NOTICE OF A TYPE I DECISION ON A PROPOSAL IN YOUR NEIGHBORHOOD

CASE FILE NUMBER: LU 19-209461 DZ: "SMALL CELL" RADIO FREQUENCY ANTENNA ADDITIONS TO MACKENZIE HALL

MACKENZIE HALL
3181 SW SAM JACKSON PARK RD
PORTLAND, OR 97239

(E) & (N)WEST ELEVATIONS

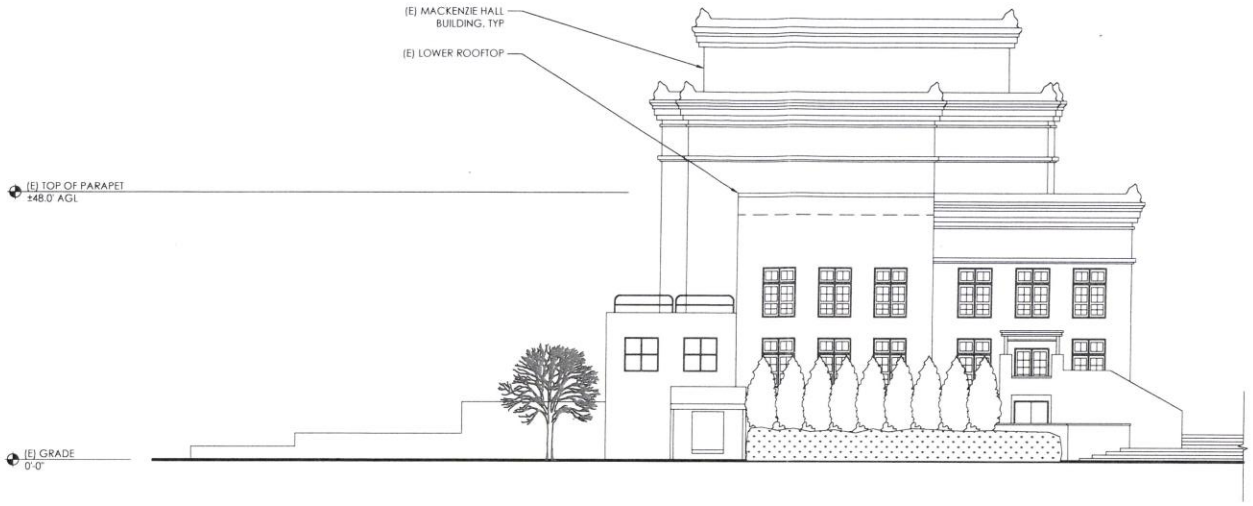
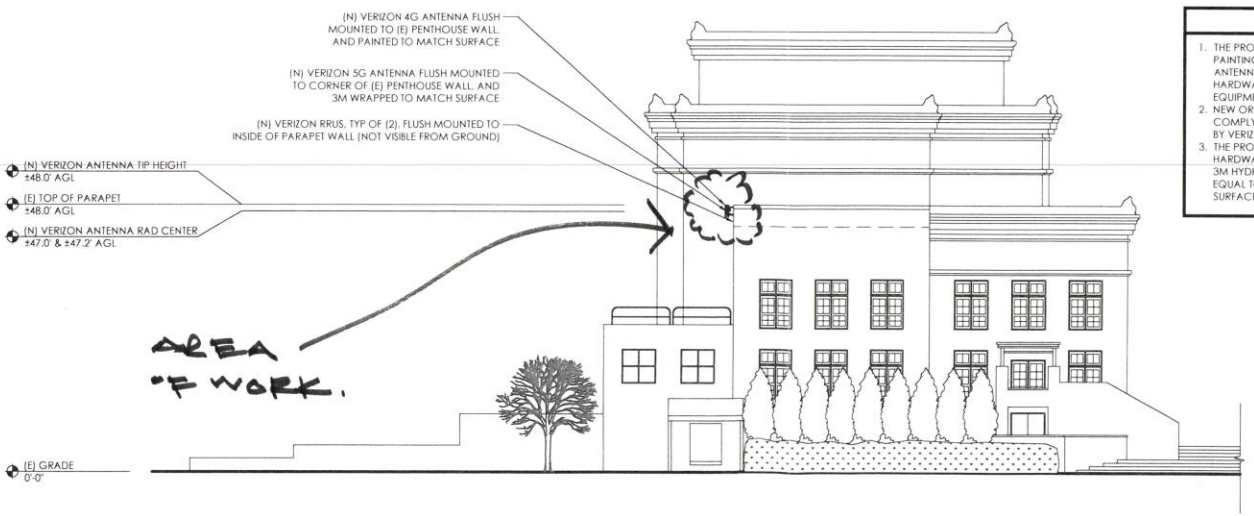
> **Findings for 2 and 6:** While small in size and not located directly on top of the roof, the two proposed antennas do have a visual impact to the roof top area of the north elevation of the addition to MacKenzie Hall. Because there are no antennas, mechanical equipment, etc. on the north elevation of the addition, the proposed development subsequently impacts the pedestrian network as well. Although the north elevation wall is clearly an end wall, having none of the brick work or ornamental investment of the west and south elevations of the addition, the elevation is also

entirely clear of extraneous equipment with an unadorned parapet and a "cornice" that appears to be the metal flashing atop the parapet. This is in stark contrast to the rich and decorative cornice ornamentation at the parapet that is evident on the original MacKenzie Hall building to the east. Because of the back-of-house and utilitarian nature of the north elevation of the MacKenzie Hall addition, and because the north elevation of the addition is a blank wall that is recessed back approximately 13 feet from the original MacKenzie Hall, staff believes this is an acceptable location for limited radio frequency antenna installation. However, in an effort to ensure that future radio frequency antenna installations do not migrate to the original MacKenzie Hall building, or the other elevations of the addition, where they would impact the architectural integrity of the building, staff has added the condition of approval that the concealment for all antennas is that they be: located at, but not above, the parapet; painted (or filmed – as is the case with the 5G antennas) to match the predominant field color of the building wall (currently beige); be located on the north wall plane of the MacKenzie Hall addition and not less than 10 feet from the existing corners.

C. The concealment for all antennas is that they be: located at, but not above, the parapet; painted (or filmed – as is the case with the 5G antennas) to match the predominant field color of the building wall (currently beige); be located on the north wall plane of the MacKenzie Hall addition and not less than 10 feet from the existing corners.
